Décarbonation énergétique LPF & BSST – draft P&ID

Projet Décarbonation LPF & BSST · drawing PID-LPF-BSST-001 · revision A (draft for review) · generated 2026-10-23

DRAFT — NOT FOR CONSTRUCTION
Every addition is pending engineering review. Nothing was invented that the specification does not state.

PROJECT	DRAWING	SHEET	REV.	STATUS
Projet Décarbonation LPF & BSST	**Overview – sheets and the services between them**	2 of 10	A	**DRAFT – pending engineering review**

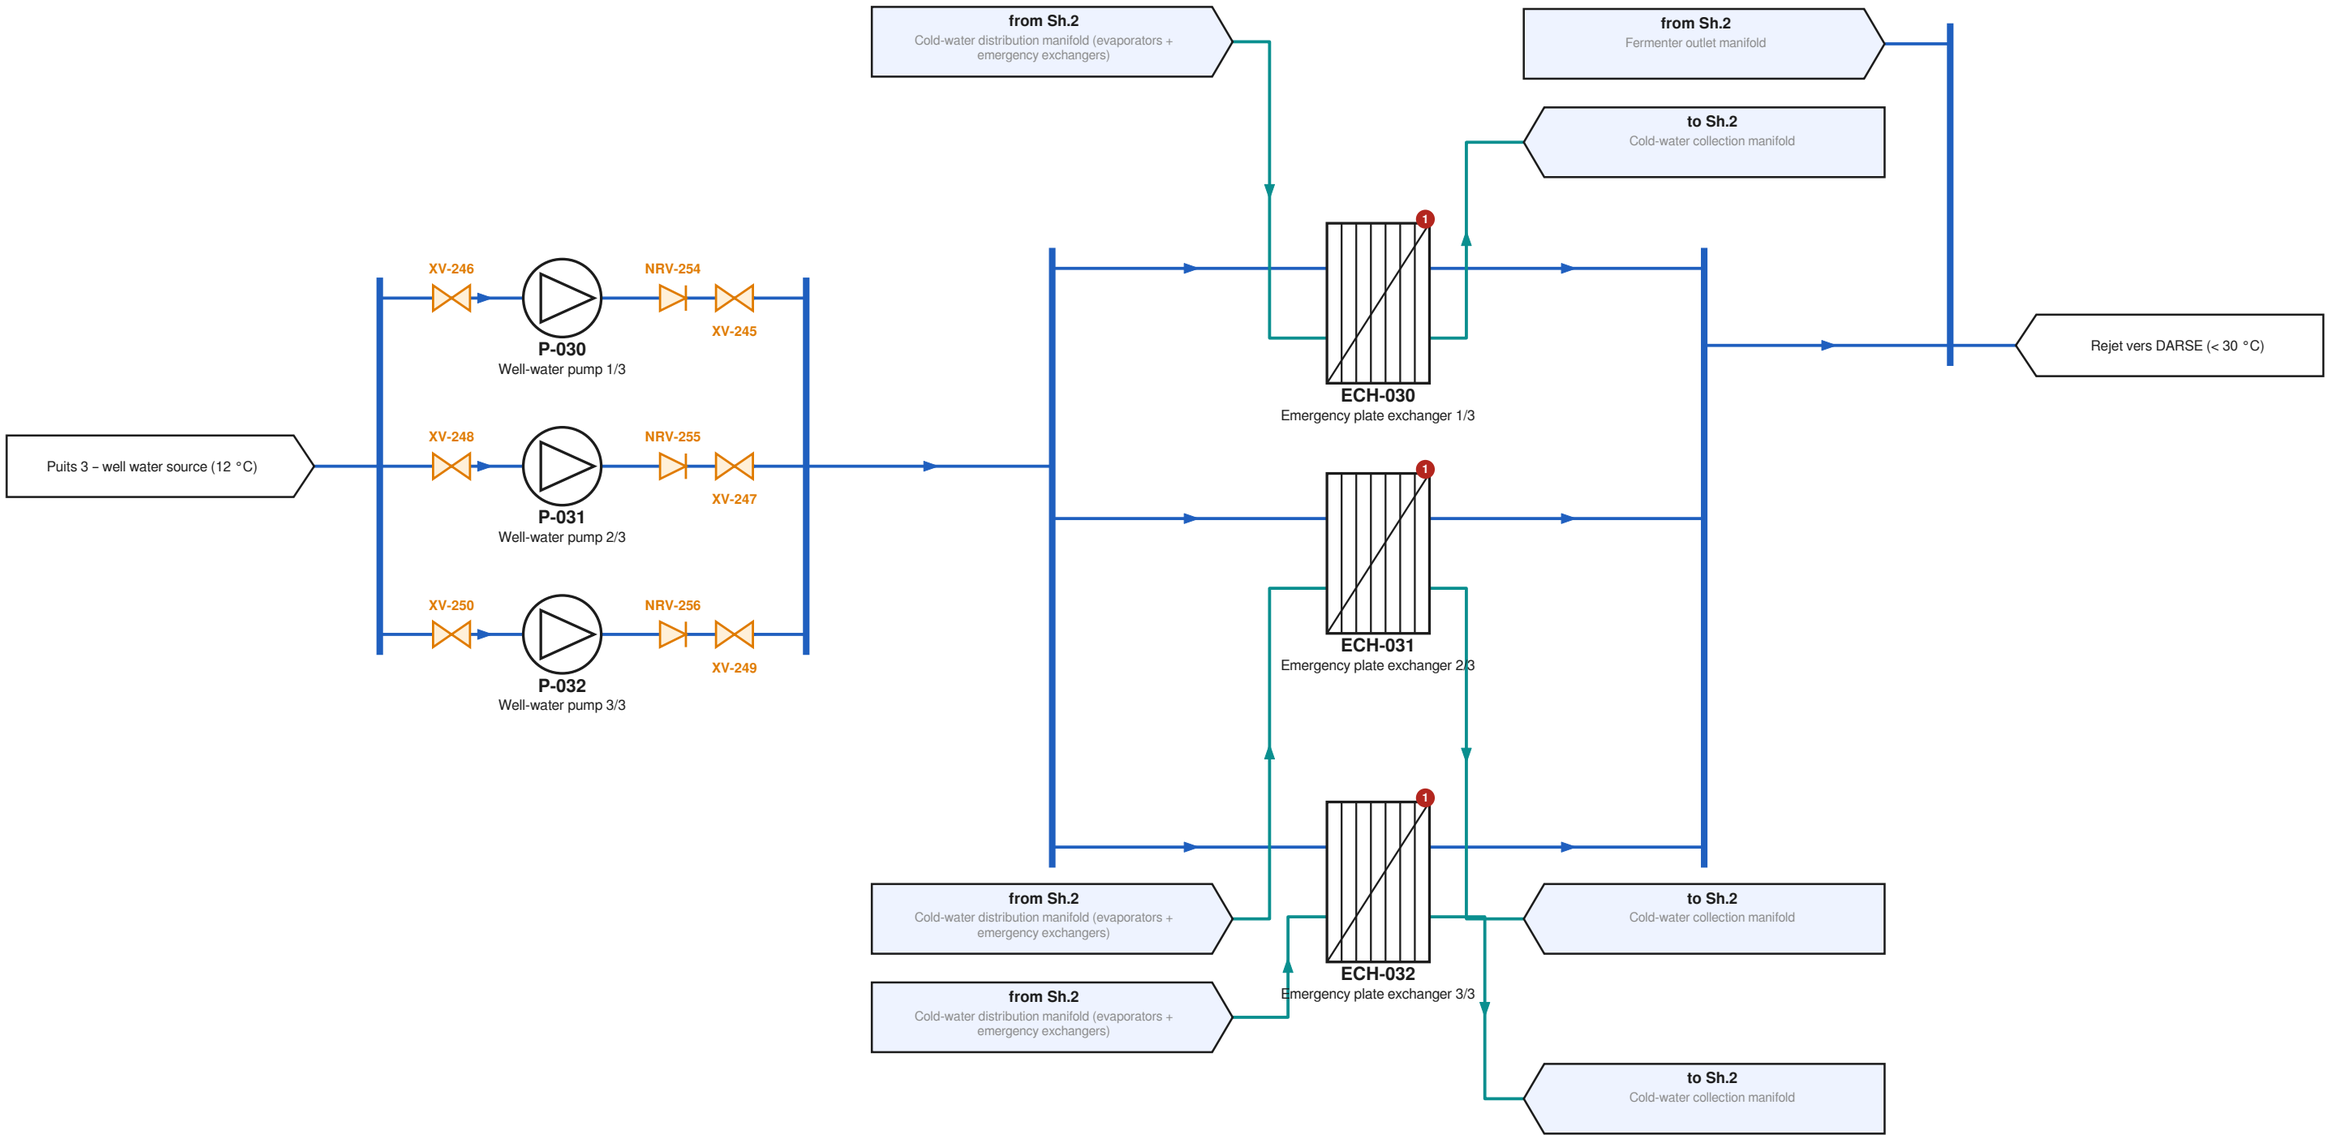
1. Position of the emergency exchangers (ECH-030..032) on the cooling loop is ambiguous. §4 'Mode Normal' reads like a series path (through the exchangers, then to the PAC); §4 'Secours Échangeurs' (PAC isolated, exchangers cooling)…
21. Valve technology is not specified for these valves. They use the explicitly identified generic DEXPI representation (CustomOperatedValve, 'technology to be selected'); no specific valve type was chosen.

PROJECT	DRAWING	SHEET	REV.	STATUS
Projet Décarbonation LPF & BSST	**Well water and emergency exchangers**	Sheet 1 of 8	A	**DRAFT – pending engineering review**

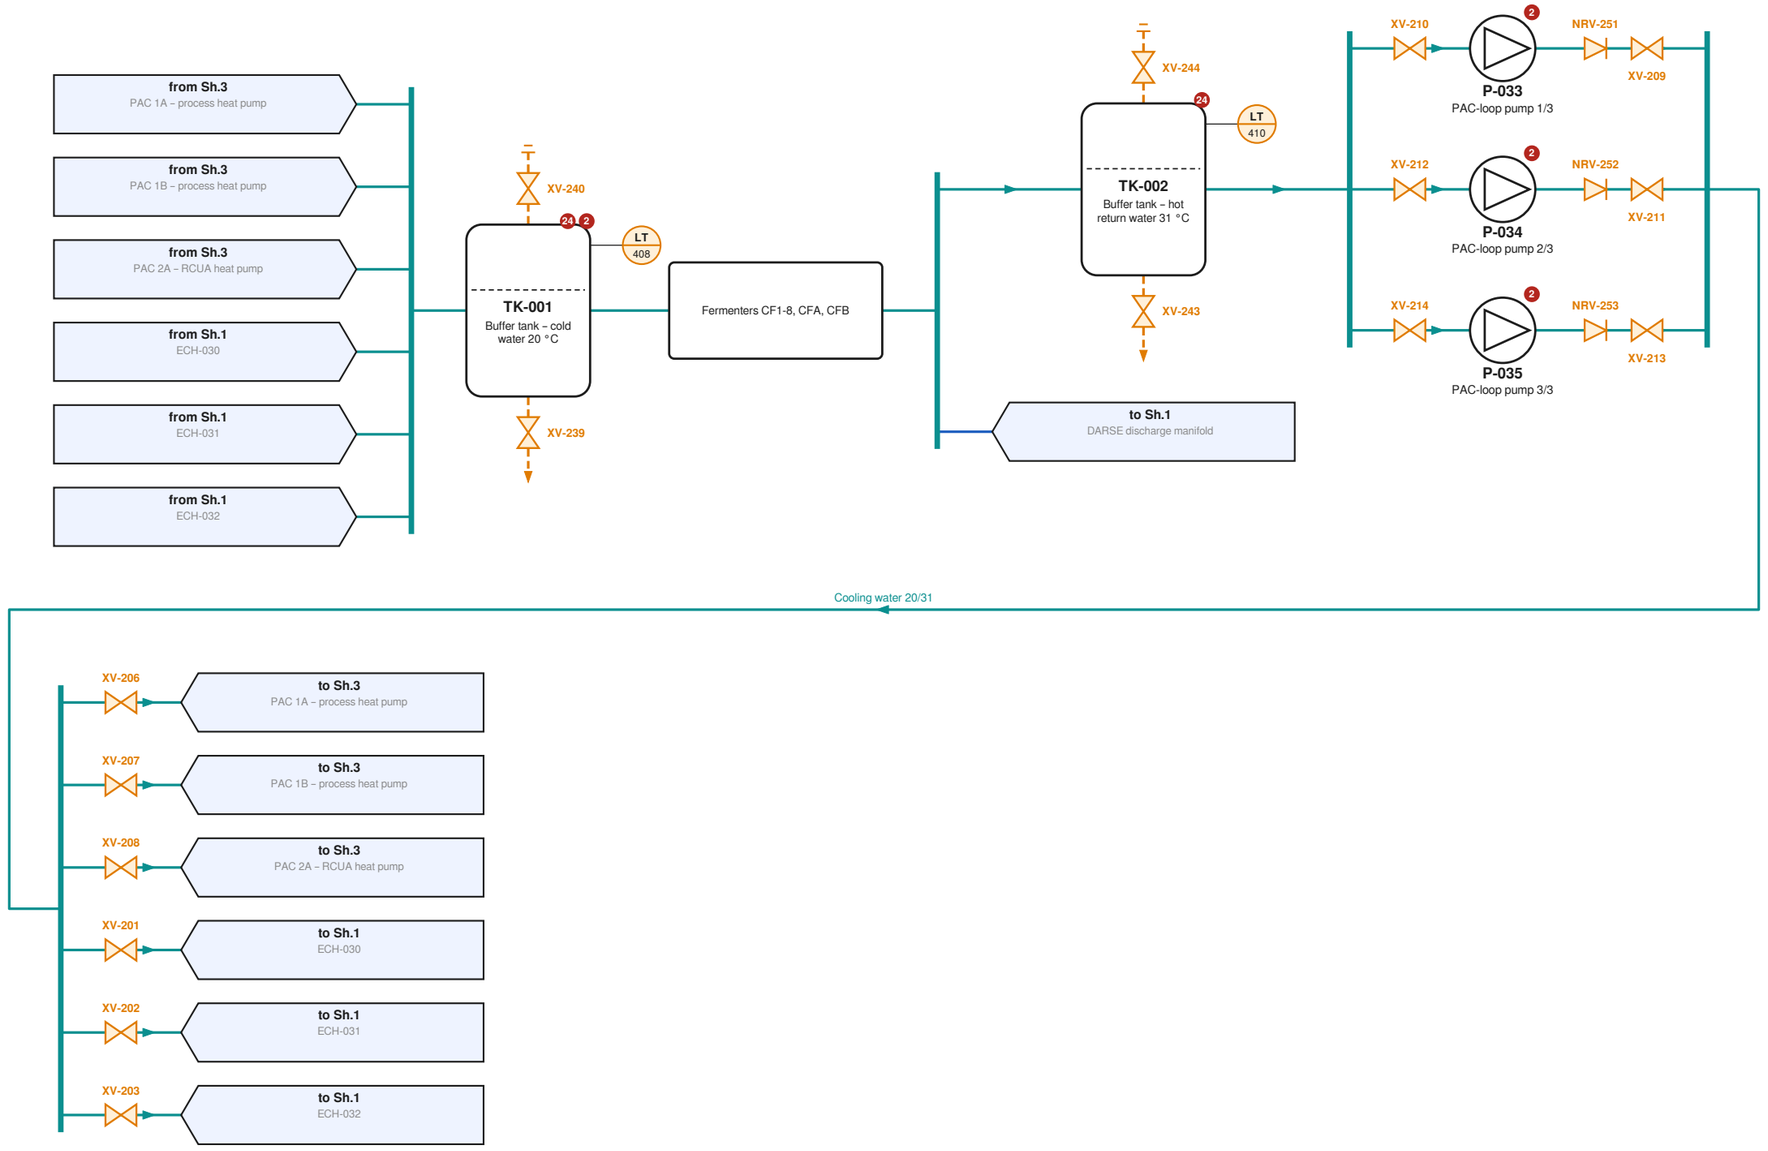
1. Position of the emergency exchangers (ECH-030..032) on the cooling loop is ambiguous. §4 'Mode Normal' reads like a series path (through the exchangers, then to the PAC); §4 'Secours Échangeurs' (PAC isolated, exchangers cooling)…

2. Pumps P-033..035 are called 'Pompage Secondaire (Boucle PAC)'; no circulation driver is stated for the TK-001 → fermenters leg or for the hot-water loops (PAC condensers, 90 °C and RCUA distribution). Pumps were not invented; P-033..035…

15. Ultimate mode: how well water reaches the fermenters (feed line) is not described; only the post-fermenter discharge to DARSE is.
21. Valve technology is not specified for these valves. They use the explicitly identified generic DEXPI representation (CustomOperatedValve, 'technology to be selected'); no specific valve type was chosen.

24. Nozzles added for drain, vent and level tapping have no nozzle number and no size.

PROJECT	DRAWING	SHEET	REV.	STATUS
Projet Décarbonation LPF & BSST	**Cooling-water loop – fermenters, buffer tanks, PAC-loop pumps**	Sheet 2 of 8	A	**DRAFT – pending engineering review**

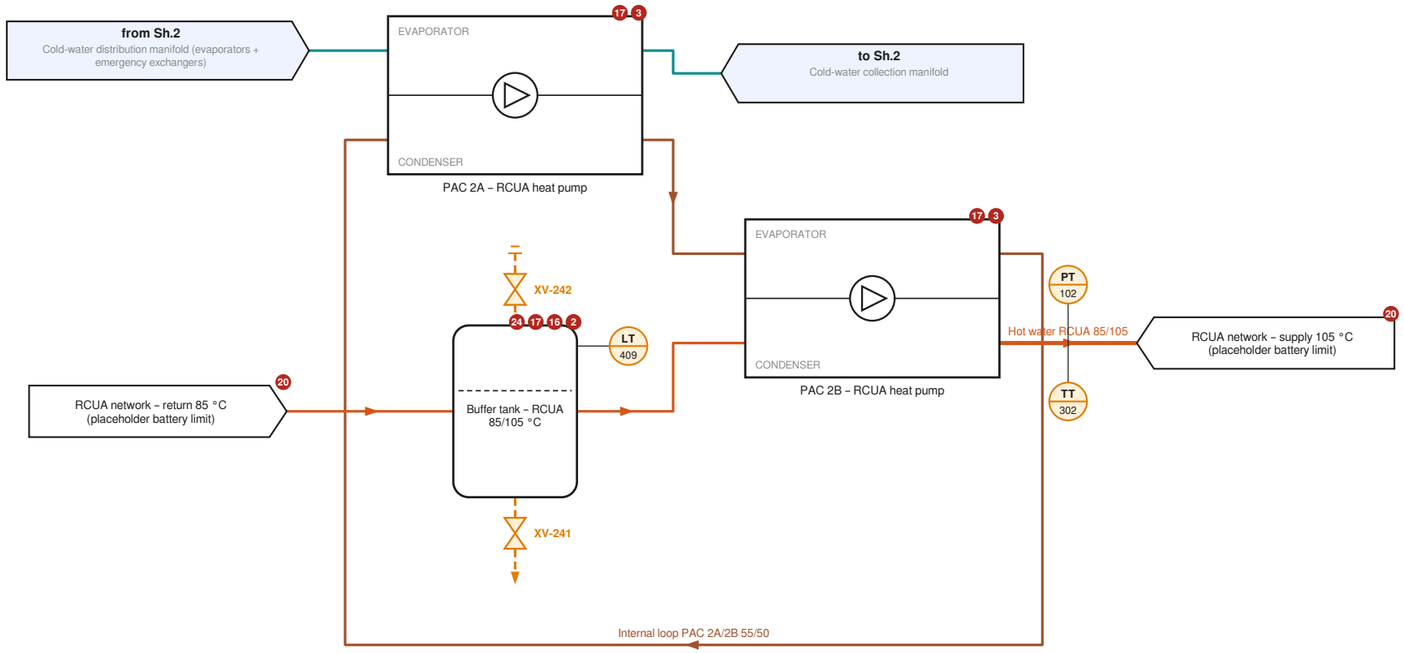
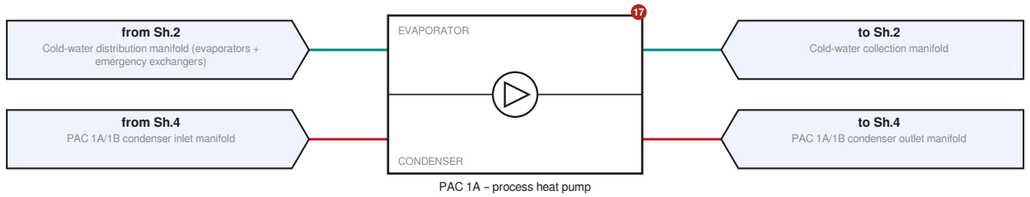
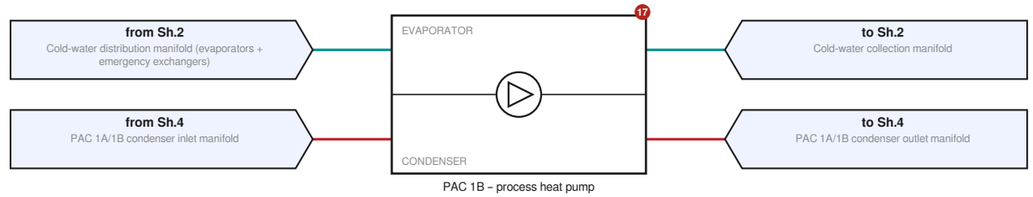
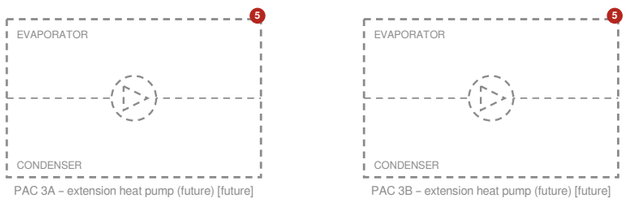
2. Pumps P-033..035 are called 'Pompage Secondaire (Boucle PAC)'; no circulation driver is stated for the TK-001 → fermenters leg or for the hot-water loops (PAC condensers, 90 °C and RCUA distribution). Pumps were not invented; P-033..035…

3. PAC 2A/2B: the table gives both units a 31/20 °C cold regime and 85/105 °C hot regime, but §2 routes the 2A condenser outlet (55 °C) into the 2B evaporator inlet. Modelled as a physical cascade: 2A evaporator on the cooling loop; 2A condenser…

5. PAC 3A/3B are future equipment with no capacity, regime or connection data. They are drawn dashed (LifeCyclePhase=Future) and left unconnected.
16. 'RCUA (85°C / 105°C)' is read as a single buffer tank. The PDF lists five buffer tanks (TK-001, TK-002, 70 °C, 90 °C, RCUA).

17. Equipment tags are given only for P-030..035, ECH-030..032, TK-001/002, K3/MESSO/GEA and the LPF tanks. Heat pumps, 70/90/RCUA tanks, flash tank, CMV stages, boiler and the new exchangers have no tag.

20. RCUA network battery limits (destination of the 105 °C header and the 85 °C return) are not described; placeholder boundaries are used.
21. Valve technology is not specified for these valves. They use the explicitly identified generic DEXPI representation (CustomOperatedValve, 'technology to be selected'); no specific valve type was chosen.

24. Nozzles added for drain, vent and level tapping have no nozzle number and no size.

PROJECT	DRAWING	SHEET	REV.	STATUS
Projet Décarbonation LPF & BSST	**Heat pumps (PAC 1A/1B, 2A/2B cascade, future 3A/3B) and RCUA loop**	Sheet 3 of 8	A	**DRAFT – pending engineering review**

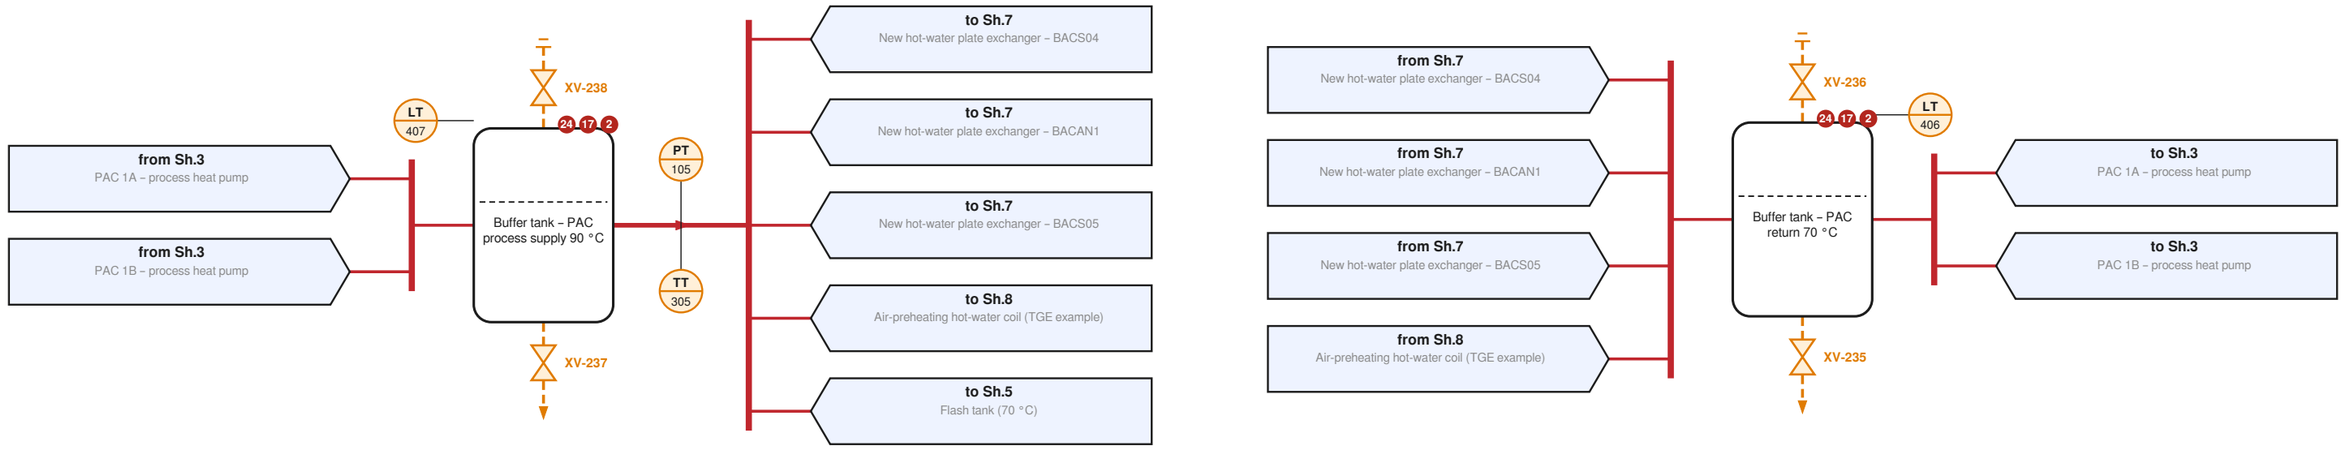
- (2) Pumps P-033..035 are called 'Pompage Secondaire (Boucle PAC)'; no circulation driver is stated for the TK-001 → fermenters leg or for the hot-water loops (PAC condensers, 90 °C and RCUA distribution). Pumps were not invented; P-033..035…
- (17) Equipment tags are given only for P-030..035, ECH-030..032, TK-001/002, K3/MESSO/GEA and the LPF tanks. Heat pumps, 70/90/RCUA tanks, flash tank, CMV stages, boiler and the new exchangers have no tag.
- (21) Valve technology is not specified for these valves. They use the explicitly identified generic DEXPI representation (CustomOperatedValve, 'technology to be selected'); no specific valve type was chosen.
- (24) Nozzles added for drain, vent and level tapping have no nozzle number and no size.

PROJECT	DRAWING	SHEET	REV.	STATUS
Projet Décarbonation LPF & BSST	**Hot-water production and distribution 90/70 °C**	Sheet 4 of 8	A	**DRAFT – pending engineering review**

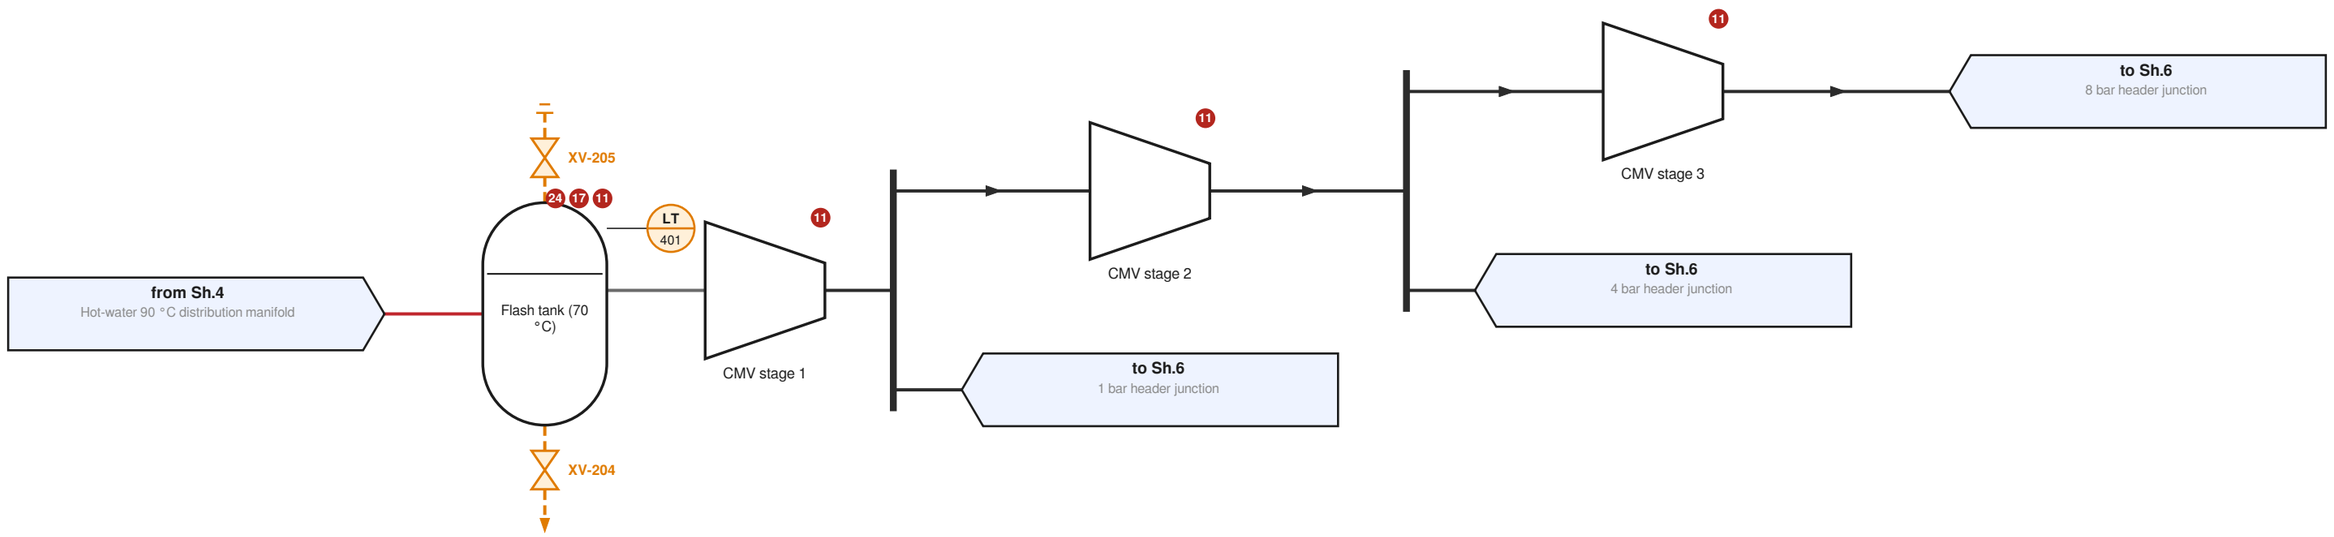
11. Flash tank: operating pressure and the destination of the 70 °C liquid are not stated; the liquid outlet is left open. The flash-vapour → CMV stage 1 and the inter-stage connections are INTERPRETED from '1 ligne ... sur 3 étages'.
17. Equipment tags are given only for P-030..035, ECH-030..032, TK-001/002, K3/MESSO/GEA and the LPF tanks. Heat pumps, 70/90/RCUA tanks, flash tank, CMV stages, boiler and the new exchangers have no tag.
21. Valve technology is not specified for these valves. They use the explicitly identified generic DEXPI representation (CustomOperatedValve, 'technology to be selected'); no specific valve type was chosen.
24. Nozzles added for drain, vent and level tapping have no nozzle number and no size.
